MIL-I-25861D (USAF)
AMENDMENT 3
24 JULY 1981
SUPERSEDING
AMENDMENT 2
21 April 1971

MILITARY SPECIFICATION

INDICATOR, PRESSURE, HYDRAULIC, 0-4000 PSI
INTEGRALLY LIGHTED

This amendment forms a part of Military Specification MIL-I-25861D (USAF) dated 30 November 1967.

FIGURE 1. Dial and Pointer

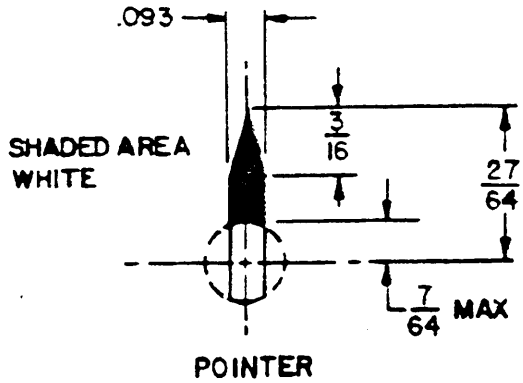
* Figure 1: Delete and substitute Figure 1 shown on Page 4 of this amendment.
